RE: Comments on UC Berkeley's 2020 Long Range Development Plan (LRDP) Draft  
Environmental Impact Report

### **11.2C.182-183 RESPONSE TO COMMENT LETTERS C182 AND C183**

Source: Kaplan, "Characteristics of the Regular Adult Bicycle User"

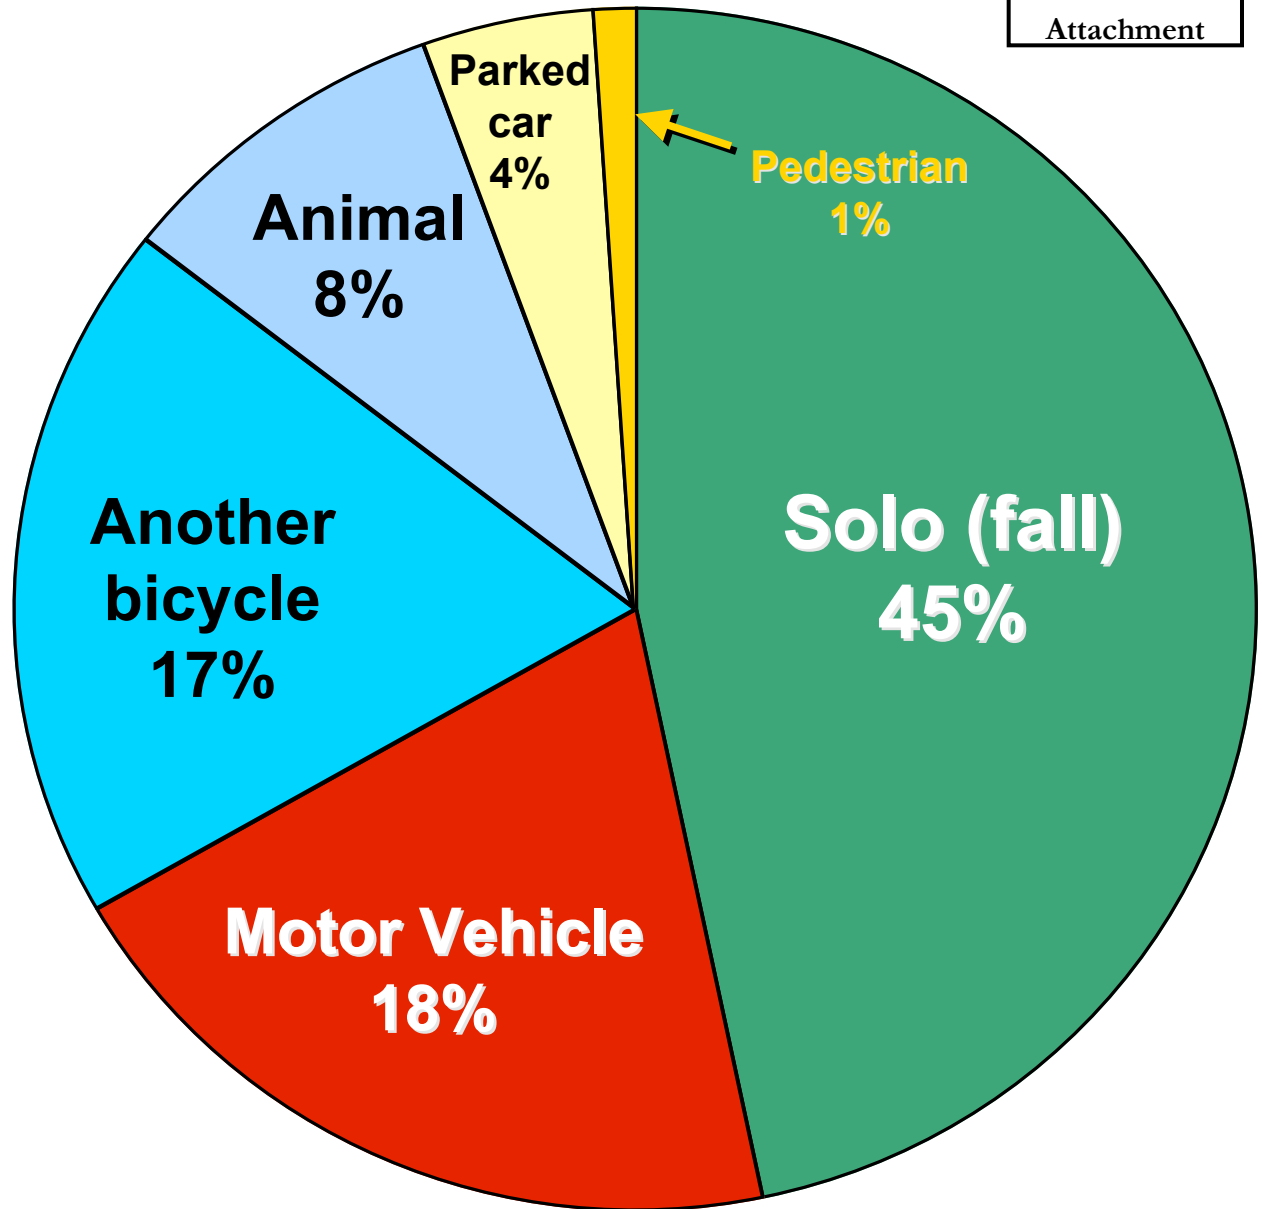
The Bicycle-Friendly Berkeley Coalition is seriously concerned and disappointed that UC Berkeley failed to study the significant traffic safety impacts of its proposed Long-Range Development Plan on bicycle and pedestrian safety caused by increased traffic on city streets. Because we feel that such significant impacts fall within the threshold requirements for study under CEQA, we respectfully request that you supplement your EIR with this requested analysis and potential mitigation measures as appropriate.

Appendix G to the CEQA Guidelines, as revised in 1998, provide an environmental impact checklist form for lead agencies preparing EIRs and "Transportation/Traffic" is one of the potential impacts to be studied. In fact, your own EIR acknowledges that impacts on transportation, and on cyclists and pedestrians in particular, need to be addressed. In the end, you simply failed to address the important traffic safety issue of increased vehicular traffic and its impact on bicycle and pedestrian safety. Your analysis was limited to the non-issue of bicycle safety as impacted by more cyclists using bikeways, and on pedestrian safety as impacted by

EIR's must propose mitigation measures and alternatives designed to minimize a project's environmental impacts and UC Berkeley must respond by mitigating or avoiding environmental impacts when it is feasible to do so. *Public Resource Code §§21002.1, 21061, 21081*. The City of Berkeley's Bicycle Plan is full of potential mitigation measures that UC Berkeley can propose to minimize its traffic safety impacts on the City. You have a legal obligation to fully study your traffic safety impacts and to propose necessary and appropriate mitigations.

The Draft EIR analyzes the impacts of implementing the 2020 LRDP. Nothing in the 2020 LRDP would increase risks to cyclists; the 2020 LRDP includes policies to further enhance cyclist safety. See pages 3.1-45 to 3.1-46 of the Draft EIR. Please also see response to comment C124-3, amending the scope of campus access improvements under the 2020 LRDP to include identification of routes suitable for mixed traffic.

The writers list existing conditions that may be exacerbated by implementation of the 2020 LRDP. Yet, as analyzed in the Draft EIR, impacts of the 2020 LRDP are not anticipated to exacerbate conditions above a threshold of significance. See the analyses for emergency access and egress at pages 4.11-12 to 4.11-15 and for impacts to sensitive biological resources, at pages 4.3-24 through 4.3-30. Safety improvements will be a study component in the pending bicycle access plan. See response to comment C13-1.

Please see response 191-1, above.
